Item No. 3.1.1
Halifax and West Community Council
June 3, 2015

SUBJECT: **Case 19646: Non-Substantive Amendments the Development Agreement
for St. Joseph's Square, Gottingen St., Halifax**

ATTACHMENT A

Proposed Amending Development Agreement

SCHEDULE B-1

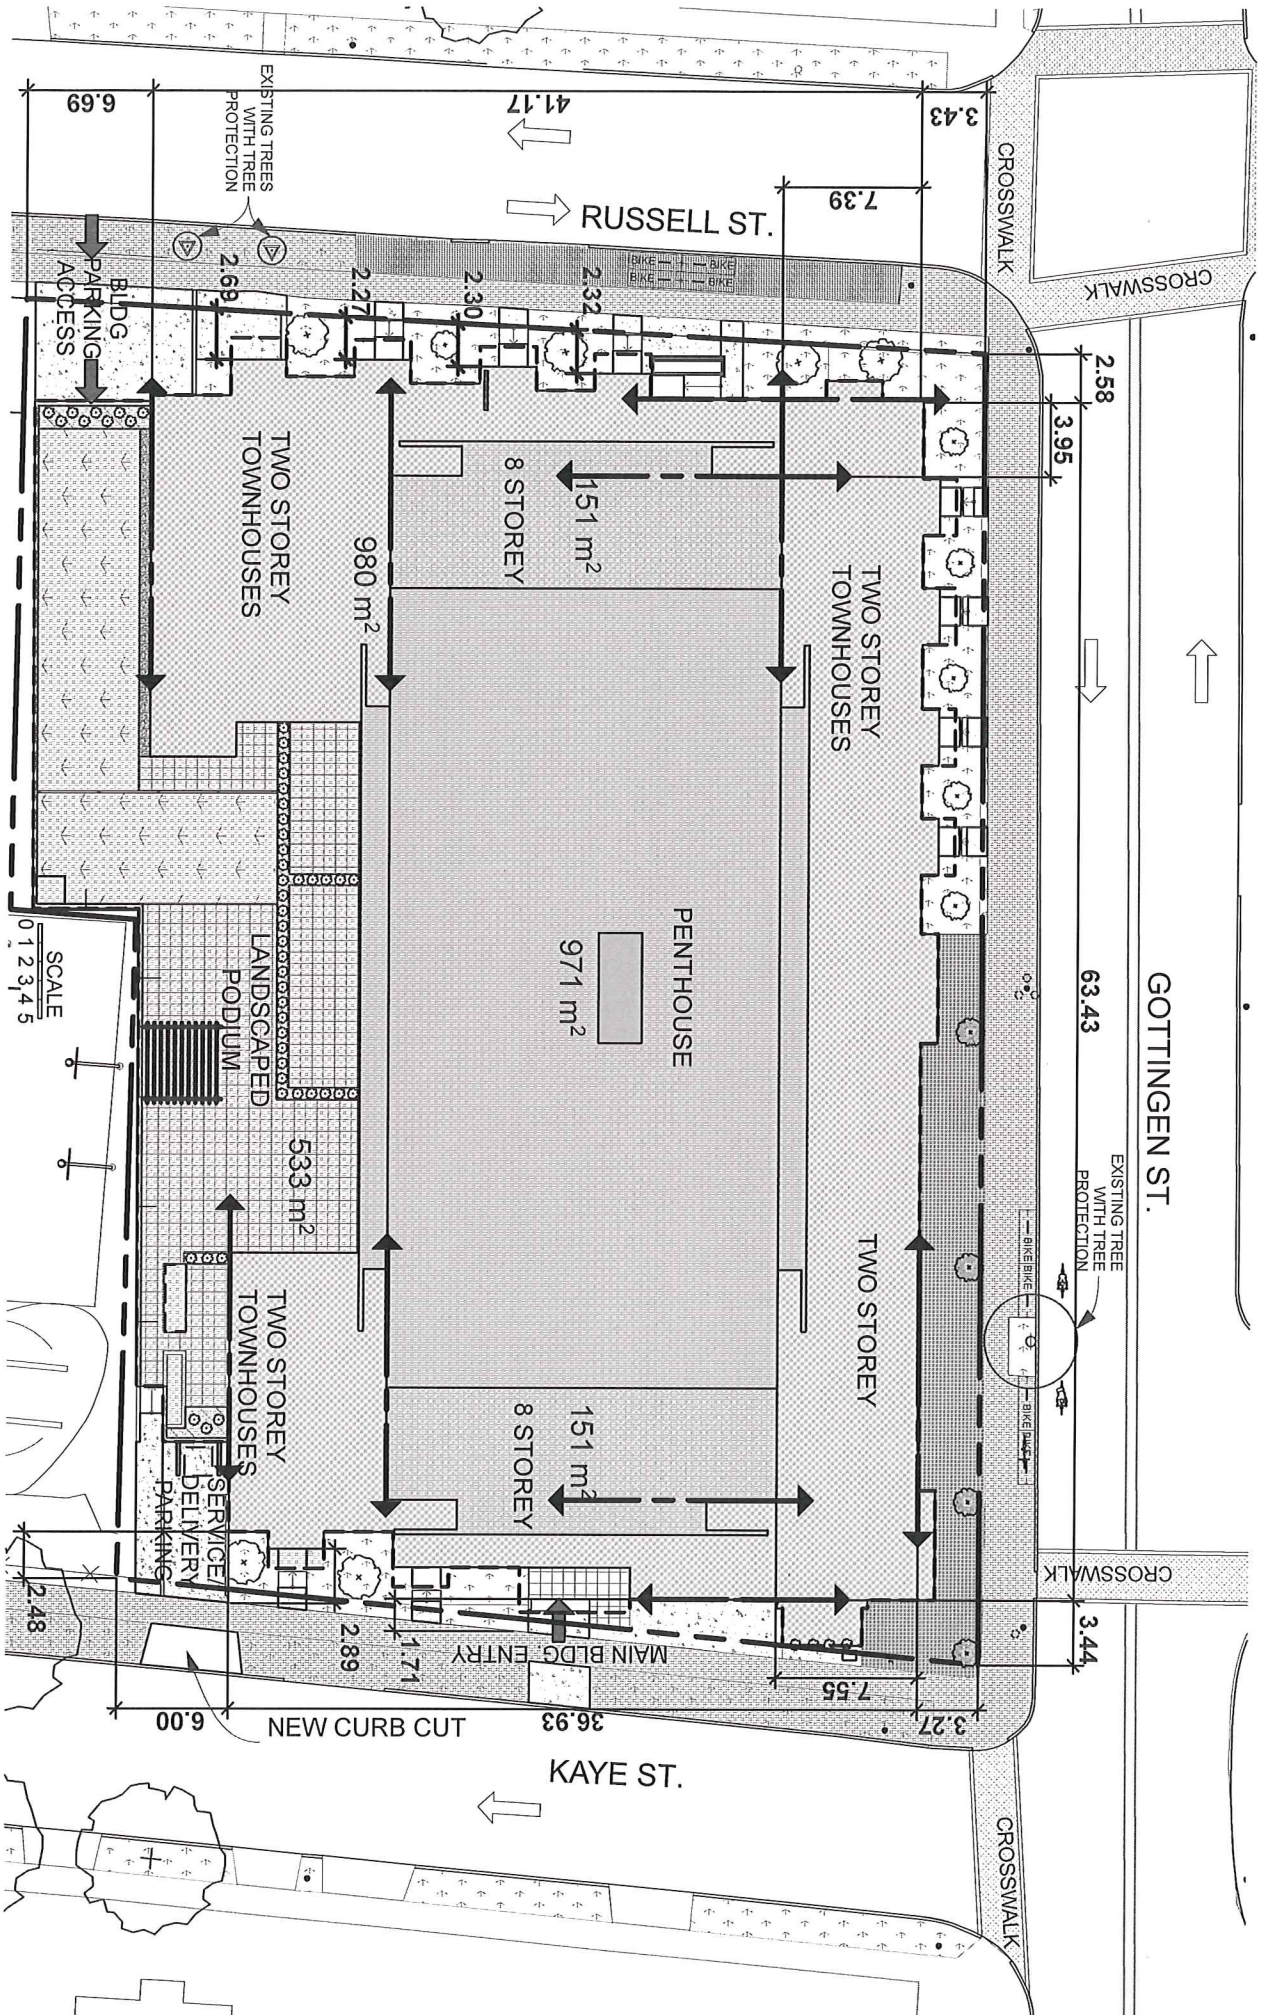
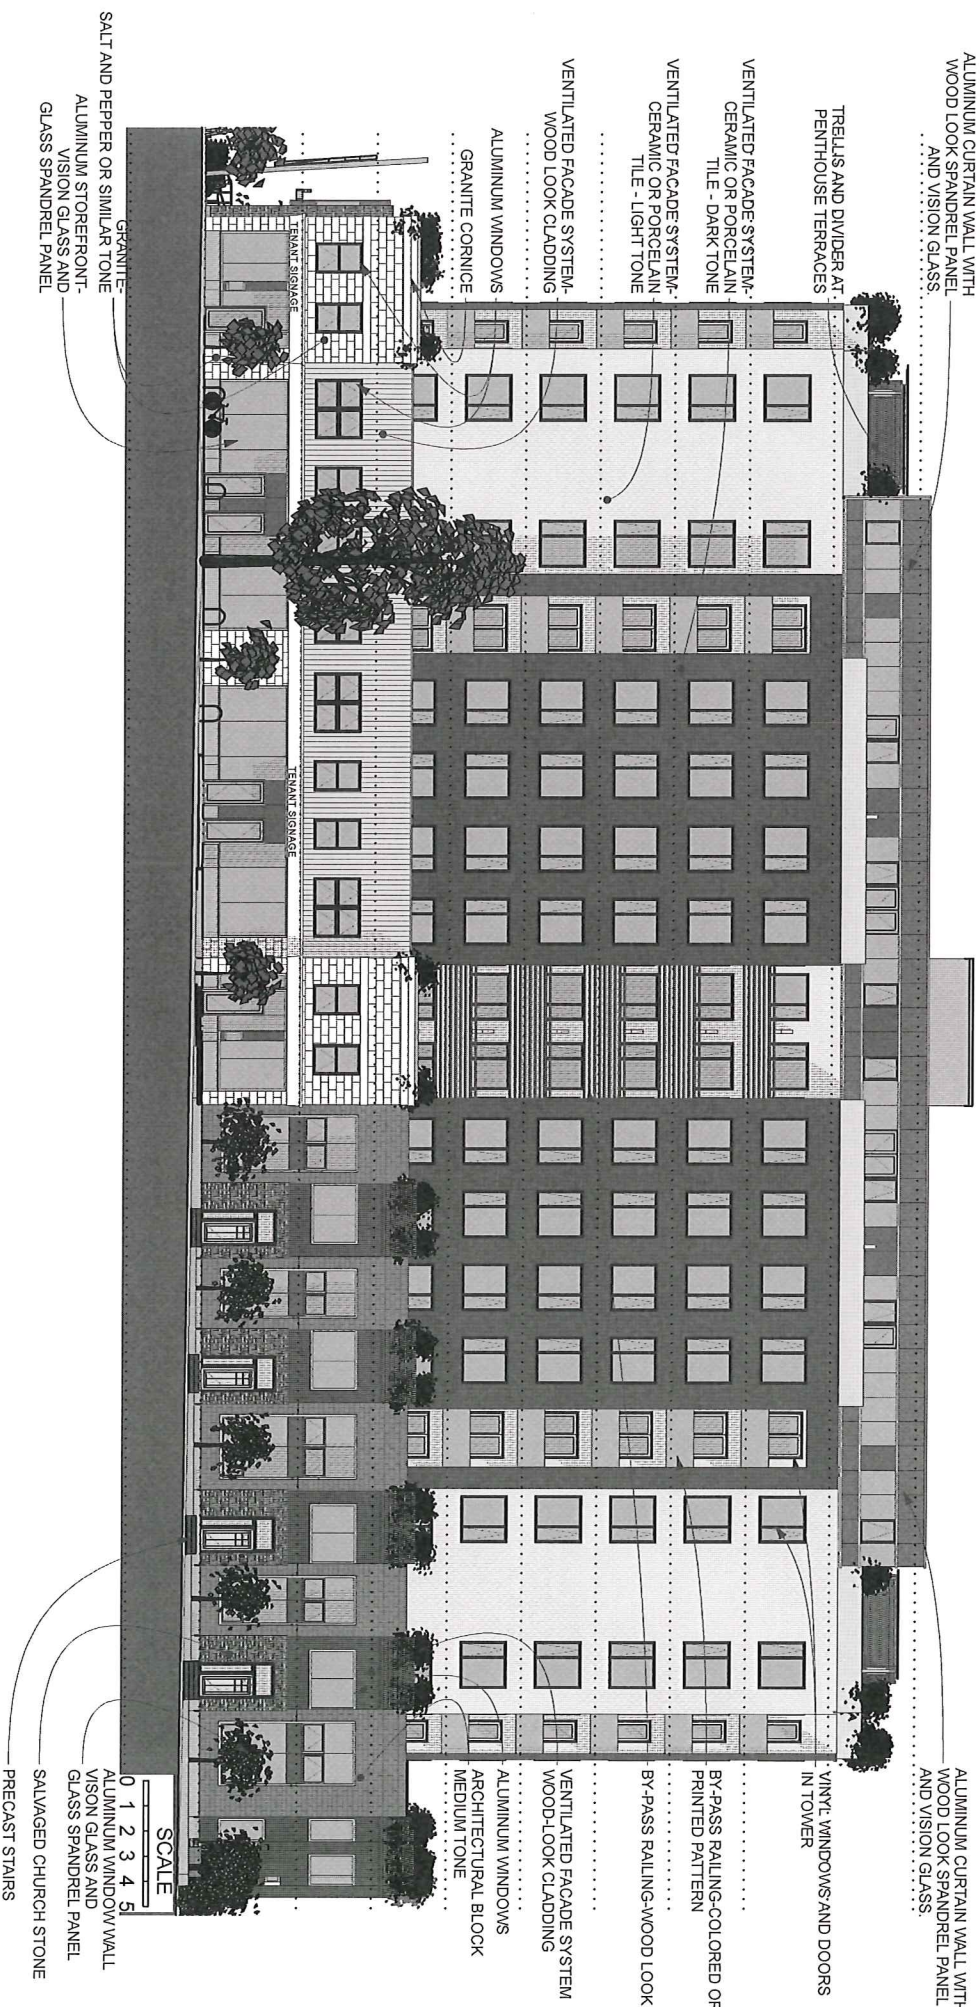
1. Section 3.1 and corresponding Schedules shall be amended by deleting and replacing Schedules B through O with the following Schedules attached to this Amending Agreement:

The survey boundaries vary slightly from the DA which was based on a lot consolidation survey showing only boundary lines dated May 11, 1999. All minimum setbacks from the boundary corners have been maintained as set out in the DA’s Schedule “B”.

The actual existing tree locations vary somewhat from that shown in DA’s Schedule 1 and the two most eastward trees along the Kaye Street boundary actually do not exist – see appendix 1. Along with the absence of two trees noted, please note that the three trees within the property lines at the Gottingen corners with Kaye and Russell Streets trees cannot be retained due to their proximity to the building foundations – see appendix 1.

The propose landscape plan respects the DA’s intend. Planters with sod and shrubs follow along the townhouse fronts and the east podium is landscaped with shrubs, sod paved areas and a gazebo. The layout has been revised due to the relocation of the residential main entry and stained glass windows, the location of the transformer pad and adjacent maintenance parking and relationship to the revised 1st floor plan.

SCHEDULE C-1

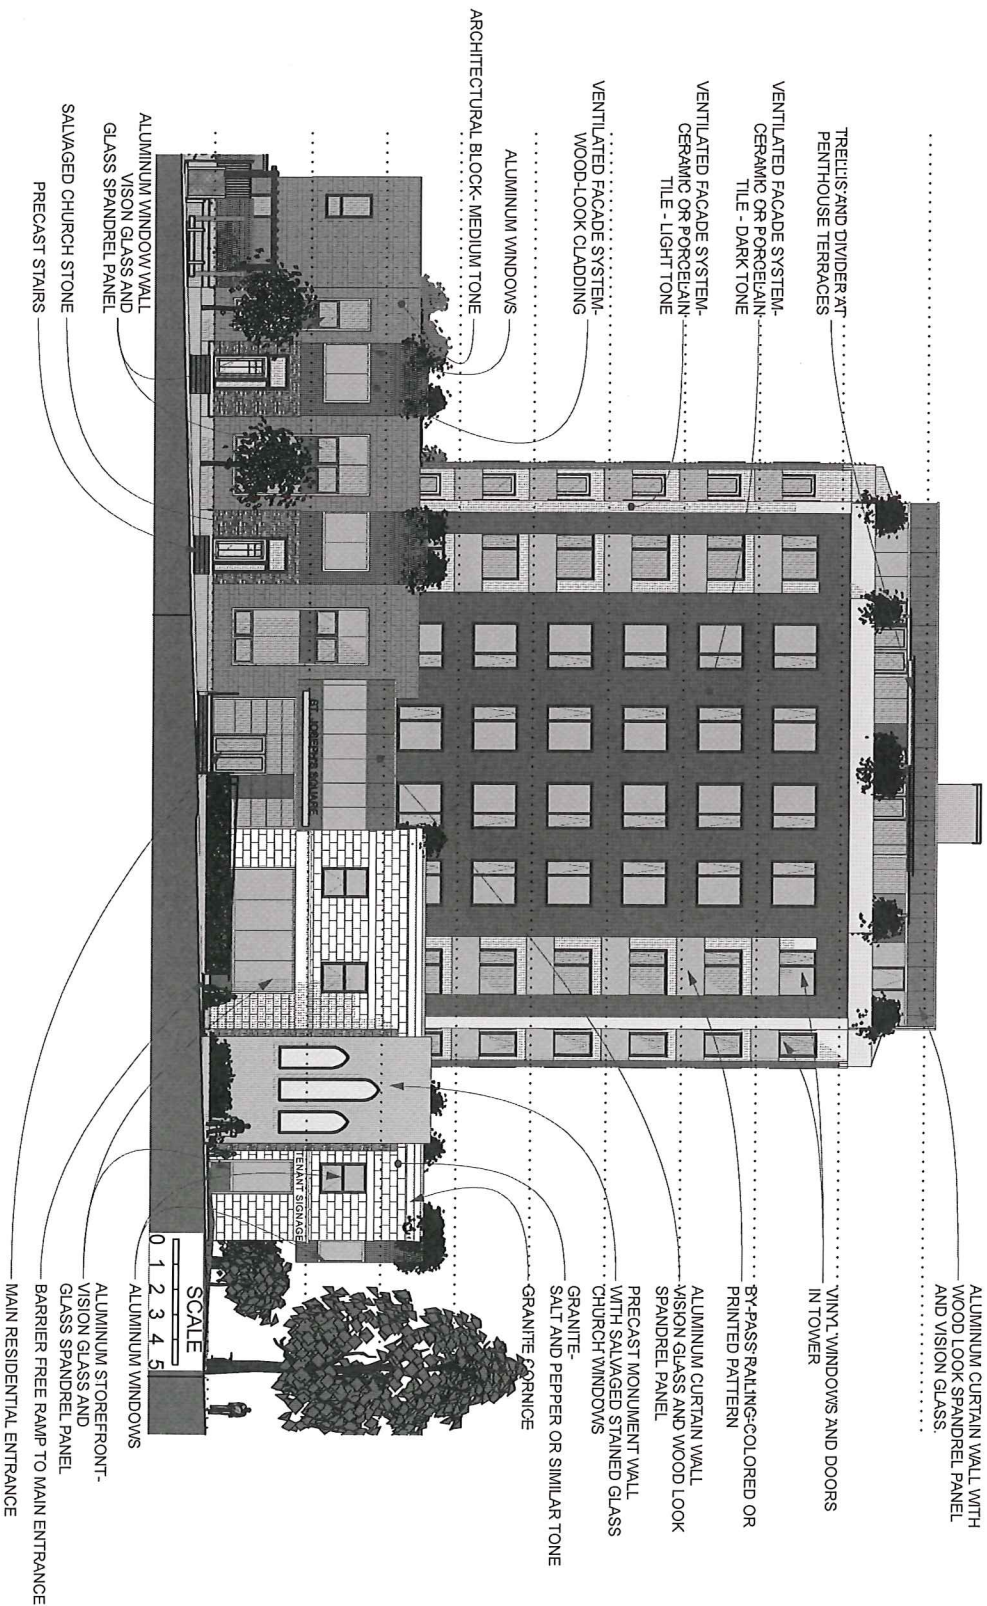
The aluminum storefronts along Gottingen Street have been revised to interpret the rhythm of the Hydrostone market including the recessed and bevelled shop windows. The windows above the shop fronts also interpret the rhythm of the residential level above the Hydrostone shops – see photo 1.

Fenestration in the tower portion maintains the DA's number of openings and single format window sizes while adopting a contemporary subdivision without transom divisions at eye level. High thermal performance triple-glazed windows will be used for the tower portion and the punched residential windows on 2 storey base, while aluminum windows, curtain wall/window wall will be used for the shop fronts and the balance of the townhouse fenestration as in the DA. The partial curtain wall treatments of the 8th and 9th floors has been reallocated to clad the entire 9th floor to provide more continuous glazing for the views.

The stained glass windows have been relocated from being engaged on the commercial frontage about a third of the way along the Gottingen Street façade to Kaye Street very near to the corner for a better exposure to the Hydrostone park and vehicular viewing while at the stops at this very busy corner. The relocation had to be considered because the salvaged stained glass church windows composition shown on the original DA are significantly smaller than actual size (2 windows 2710x780mm and one 3910x780mm versus 3 identical 2285x800mm windows).

SCHEDULE E-1

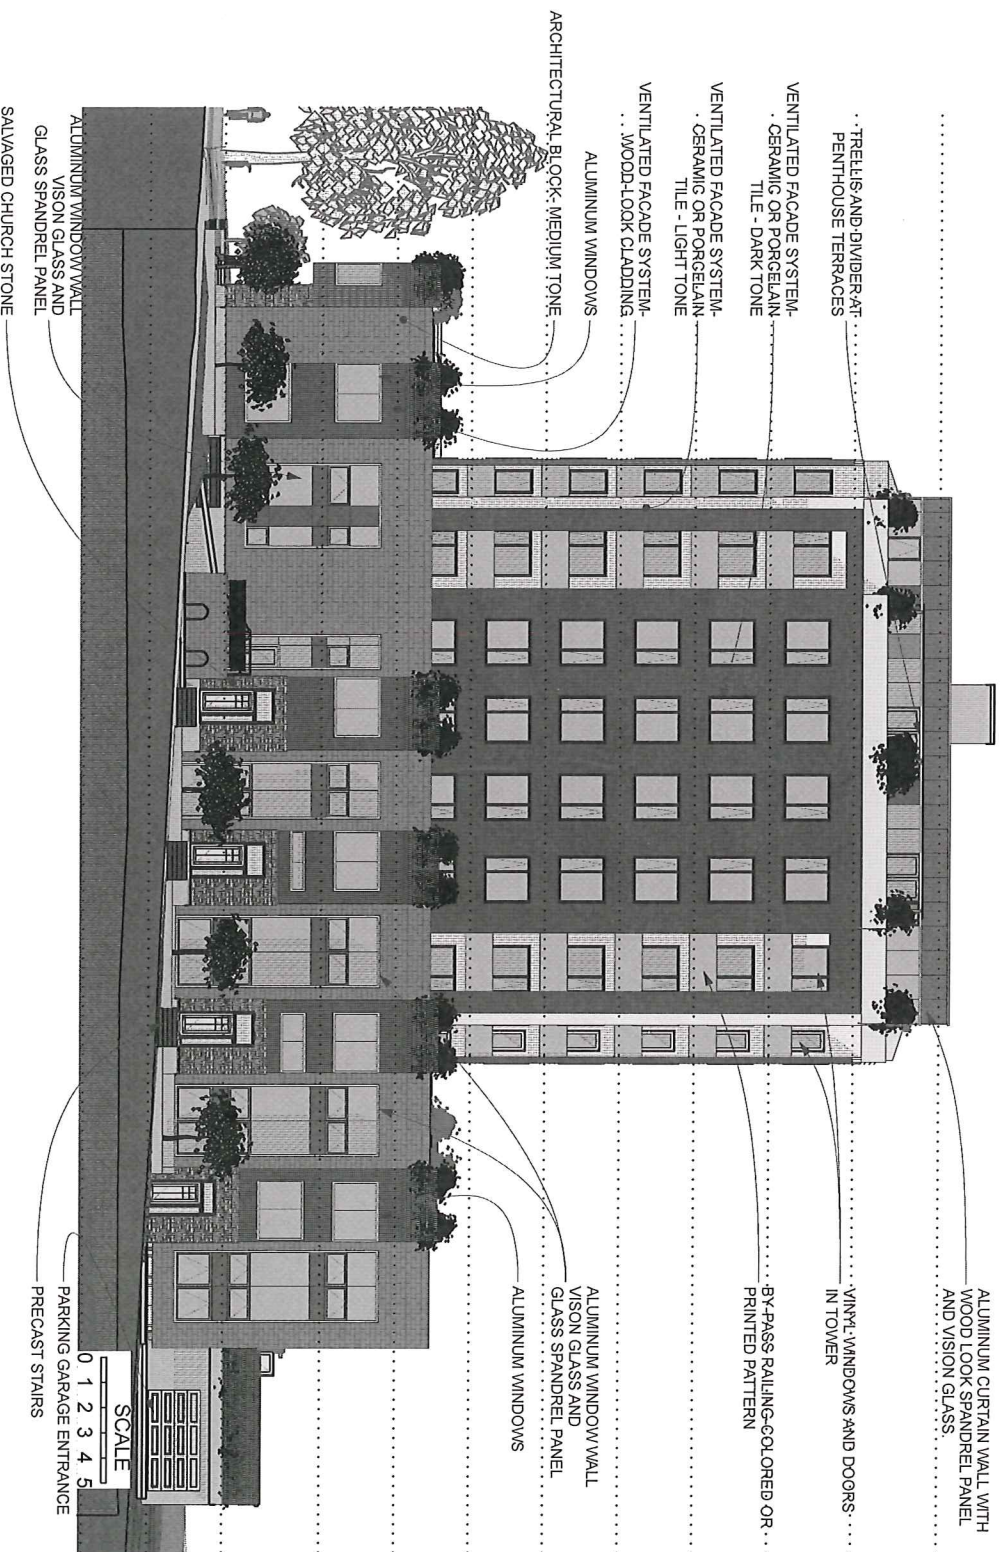
10. In Subsection 3.5.2, the text "Schedule B" shall be deleted and replaced with "Schedule B-1";
11. In Subsection 3.6.6, the text "identified as architectural concrete on Schedule E" shall be deleted and replaced with "illustrated on Schedule E-1";

SCHEDULE G-1

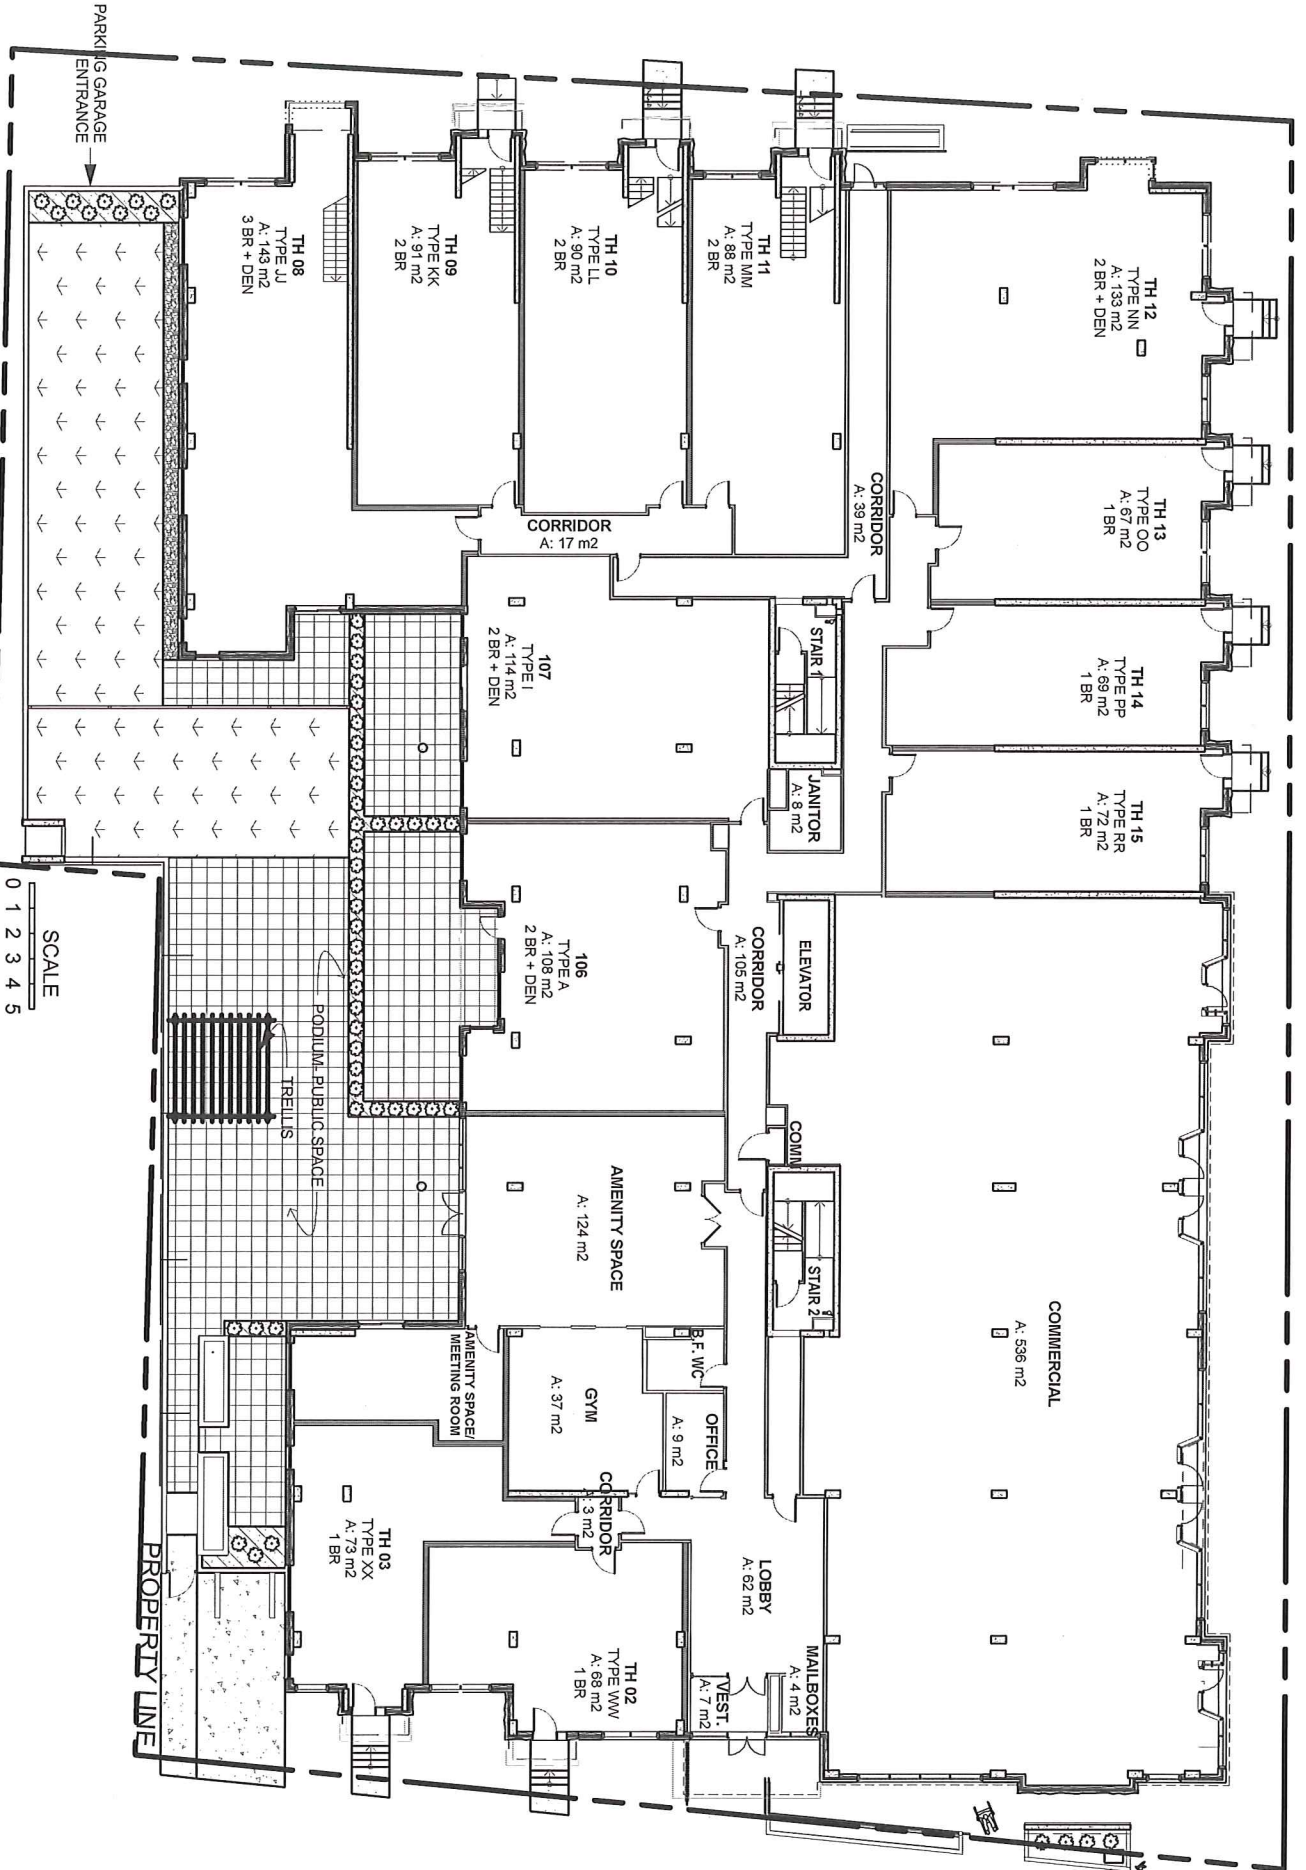
5. In Subsection 3.4.1, the text "eighty-three (83)" shall be deleted and replaced with "one hundred and six (106)";
6. In Subsection 3.4.4, the text "Schedules I and J" shall be deleted and replaced with "Schedule G-1";

To further reinforce this commercial frontage, the main residential pedestrian entrance has been moved from Gottingen Street to Kaye Street to prevent its competition with the commercial streetscape and functionally separates them.

A single 3.68 m high commercial 1st floor area has been opted over a 2-storey high space which is more in keeping with the neighborhood's commercial fabric consisting of small shops, restaurants and services. Accordingly, the portion of the second floor over the commercial level has been dedicated to residential units.
